SERVICE NO. 1350 BULLETIN

Date: December 17, 2020

**NOSE LANDING GEAR STEERING HORN AND ARM
ASSEMBLIES INSPECTION**

PA-46-350P M350
PA-46-500TP M500
PA-46-600TP M600

DETAIL B
STEERING HORN BASE (TYPICAL)
(VIEW ROTATED 90 DEGREES CW)

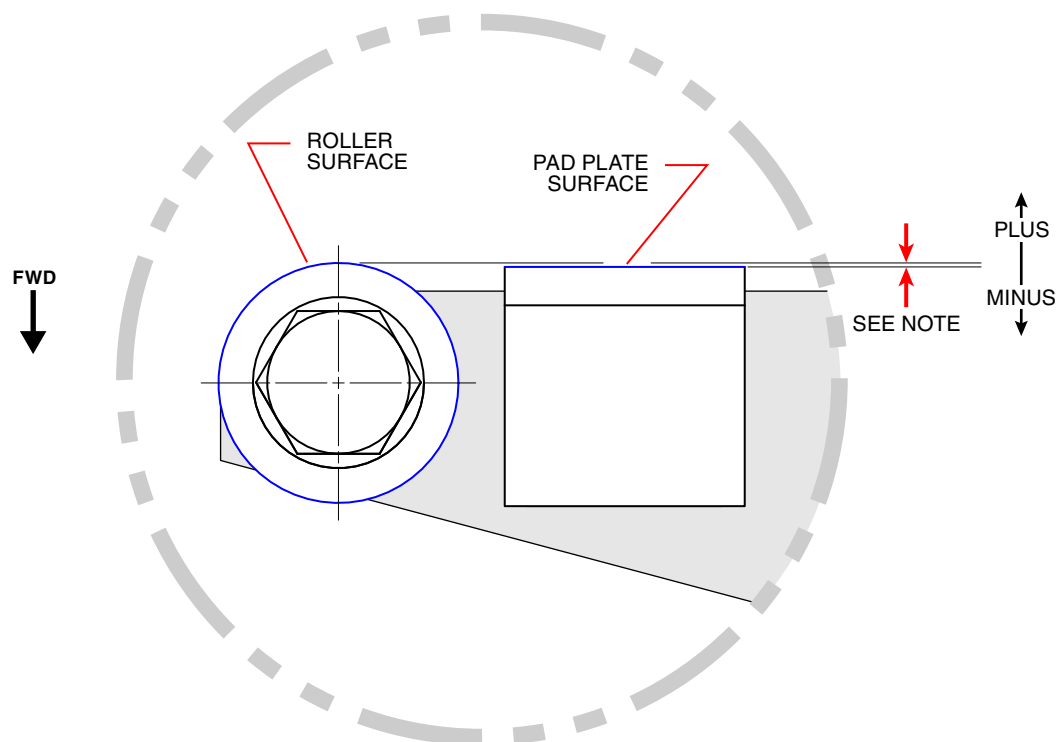
Service Bulletin (SB) 1350A supersedes SB 1350 in its entirety. Aircraft that were previously made compliant with SB 1350 must confirm that the torque of the steering horn base bolts matches that provided in Figure 1, Sheet 2, of SB 1350A.

SB 1350A updates the torque of the bolts for steering horn base in Figure 1, Detail B.

NOTE: Torque Bolts AN4H5A to 25–30 in-lb.

Figure 1 – Sheet 3 of 5
Nose Wheel Steering Assemblies – Typical

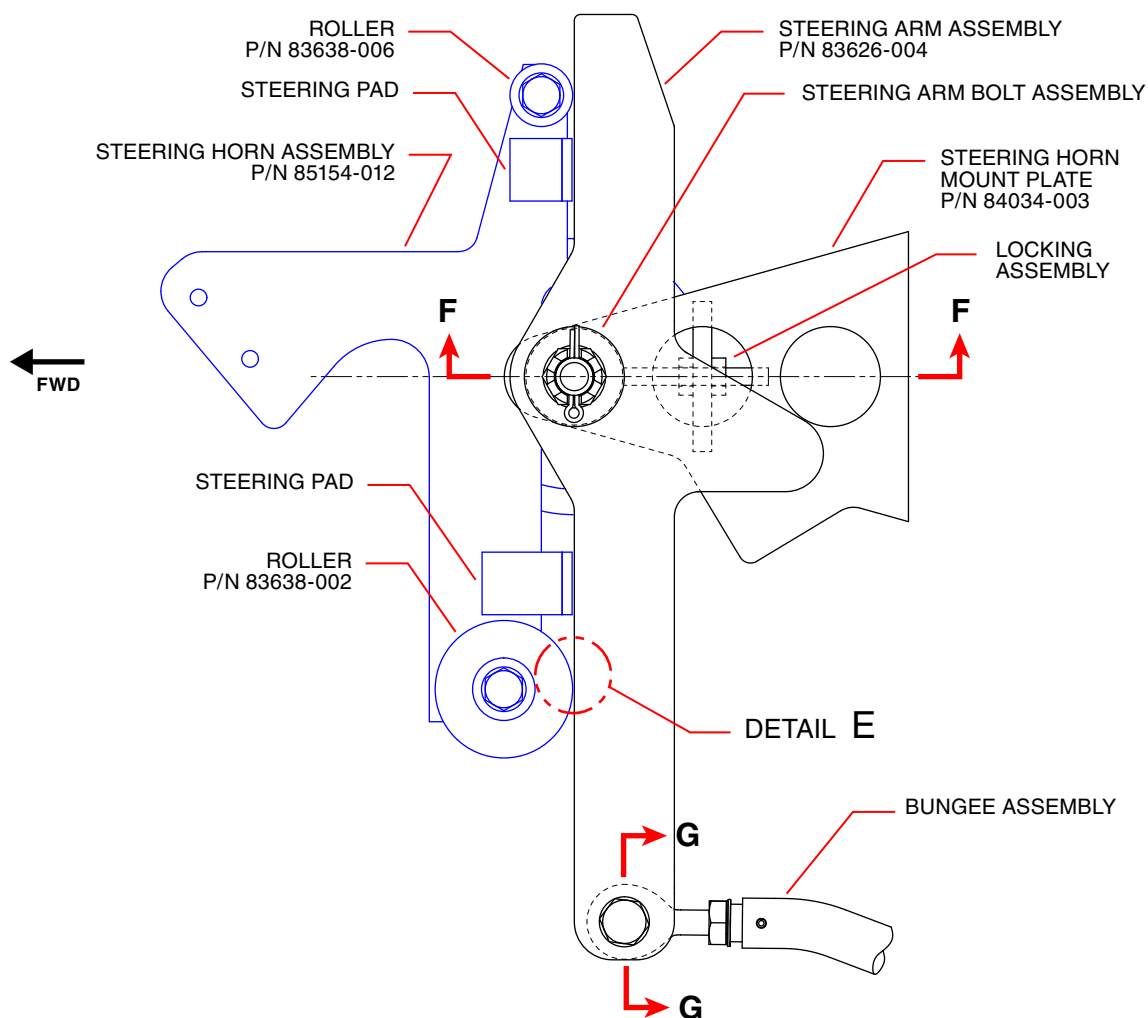
The steering pads, which are components welded onto the nose wheel steering horn assembly, may be protruding beyond the steering horn rollers on the affected airplanes. This may result in the steering pads making improper contact with the nose wheel steering arm assembly. Left uncorrected, this condition may cause damage to the steering arm assembly.

- If there is no visually apparent damage, then proceed to Step 4.
 4. Check if the steering pads and rollers are positioned correctly on the steering horn as shown in Detail C. Place the steering horn onto a flat surface, with the rollers facing the surface. Use a feeler gauge, or a shop aid of appropriate thickness, to determine if the parts are positioned as depicted in Detail C.

- If the steering pads and rollers are not positioned as Detail C shows, then the parts must be replaced, which will be accomplished in an upcoming step. Proceed to Step 5.
 - If the steering pads and rollers are positioned as Detail C shows, then it may not be necessary to replace the steering horn assembly and rollers. Proceed to Step 5.
5. Inspect the Arm Assembly, P/N 83626-004, for any signs of damage, especially in the areas where the steering pads make contact.

NOTE: The surface of both rollers must be positioned between plus 0.020 in. maximum and minus 0.001 in. maximum distance from the surface of both steering pad plates. The acceptable distance is applicable to both sides at the same time.

Figure 2

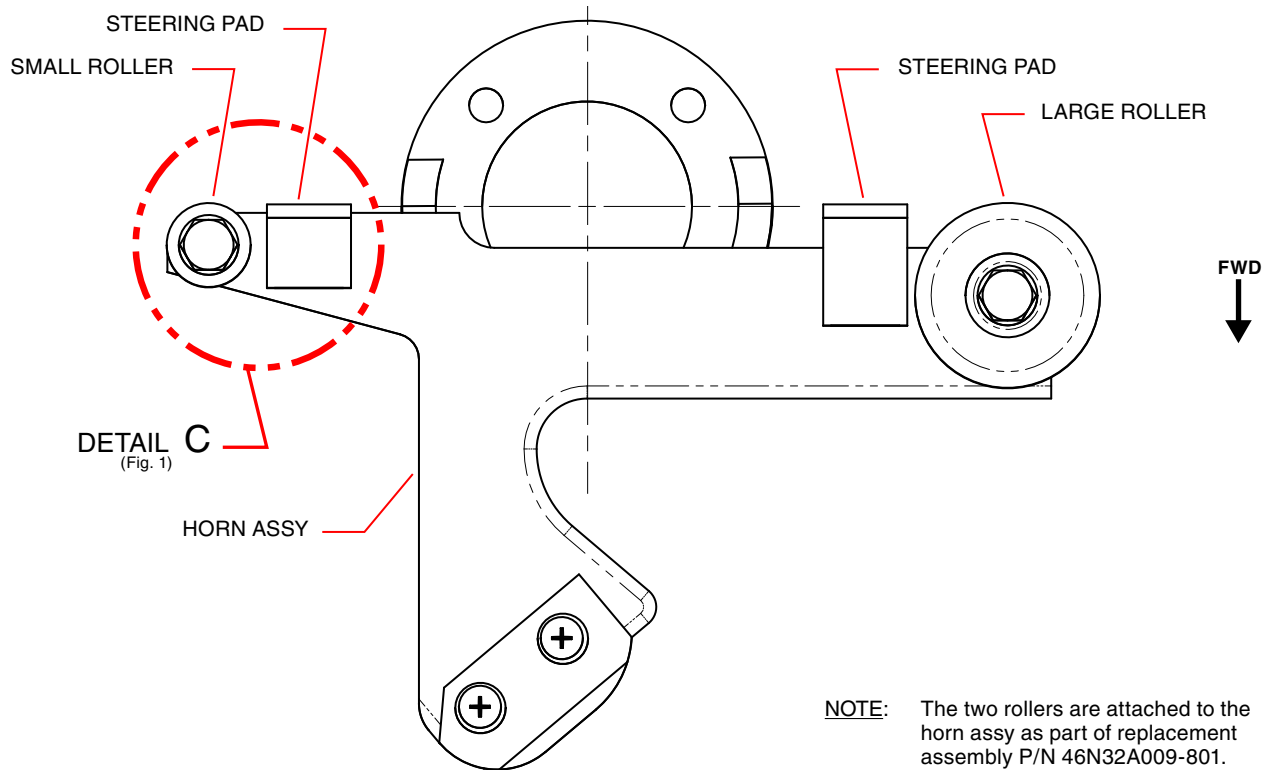
- 1) Order one (1) Nose Wheel Steering Horn and Roller Assembly, P/N 46N32A009-801, which is shown in Figure 2. This new, improved assembly replaces, as one assembly, the existing steering horn assembly (which includes the steering pads) and steering horn rollers.

- 2) Install P/N 46N32A009-801 onto the trunnion assembly, as shown in in Detail B. Torque the bolts per the note in Detail B. Safety wire the bolts with P/N 151-296 (MS20995-C32).
